Southern Nuclear Operating Company
Vogtle Electric Generating Plant Units 3 and 4
Supplement to Revised Request for License Amendment:
Containment Internal Floor Module Connections (LAR-15-012 R1S)

Supplement to Revised Request for License Amendment:

Containment Internal Floor Module Connections,

Responses to NRC Staff Comments

Figure 2: Elevation View of CA37 Floor to CA01 Wall Connection

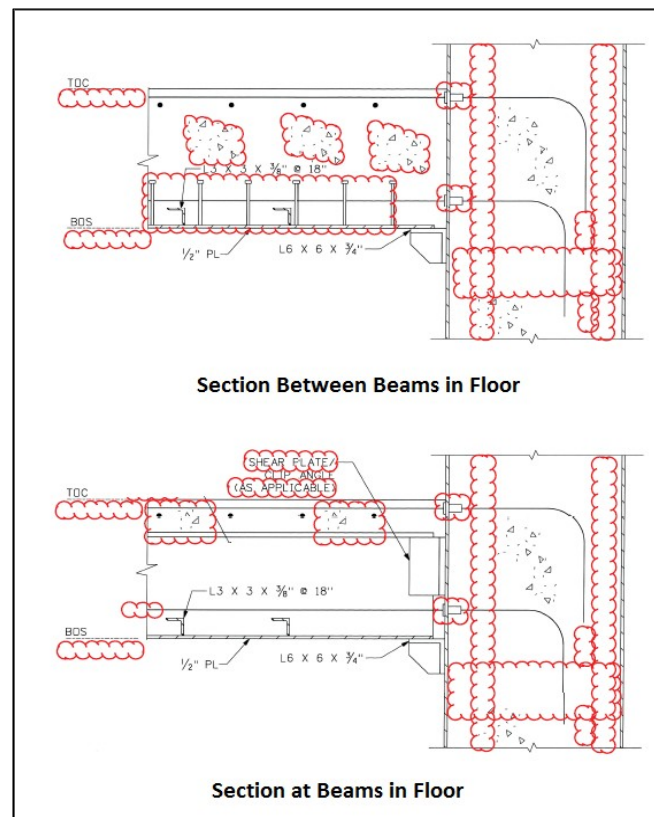
Provide a table to demonstrate the demand to capacity ratio of the connection at various sample locations, including locations where the top of the wall is at the same elevation as the top of the floor.

Figure 2 (revised UFSAR Figure 3.8.3-17 (Sheet 1 of 2) as proposed in SNC LAR-15-012R1 and shown below) shows the configuration of the CA37 module floor-to-CA01 wall connection (Area 4 in Containment, top of floor elevation 107'-2"). This connection is composed primarily of encased steel beams that are welded to continuous stiffened angle beam seats. The seats are continuously welded to the CA01 module wall faceplate. Additionally, there are top and bottom dowels that connect the CA37 floor to the CA01 wall. At some locations where the encased beams are heavier to carry heavier loads, such as the Core Makeup Tank, there are heavy beam seats instead of the continuous stiffened angle. These heavy beam seats are referred to as beam pedestals.

Table 1 describes the interaction ratios for the CA37 module floor to CA01 module wall connection (Area 4 in Containment, top of floor elevation 107'-2").

Table 1 displays the reinforcement required (see items 1 & 2 in the table) in square inches per linear foot to withstand the demand forces due to axial, bending, & twisting loads from the ANSYS finite element analysis model while neglecting the contribution of the beam seats. The capacity is presented as the available square inches of steel per linear foot.

Table 1 also displays the continuous stiffened angle floor seat (see item 3 in the table) "demand" due to tension (axial, bending, & twisting moment), in-plane shear, and out-of-plane shear loads from the ANSYS finite element analysis model, along with locked-in stress imparted to the seats during concrete placement. The forces applied at the stiffened seat for the evaluation are conservatively based on the largest demand obtained from the analysis model at the CA37 floor to wall connection, while neglecting the contribution of the bottom dowels. The continuous stiffened beam seats are demonstrated to meet the design requirements.

Finally, Table 1 also displays the beam pedestal (see item 4 in the table) "demand" due to in-plane shear and out-of-plane shear loads from the ANSYS finite element analysis model. The beam pedestals are analyzed in a similar fashion as the continuous stiffened angle beam seats with the exception that they see larger loads due to the Core Makeup Tank being supported on this area of the floor.
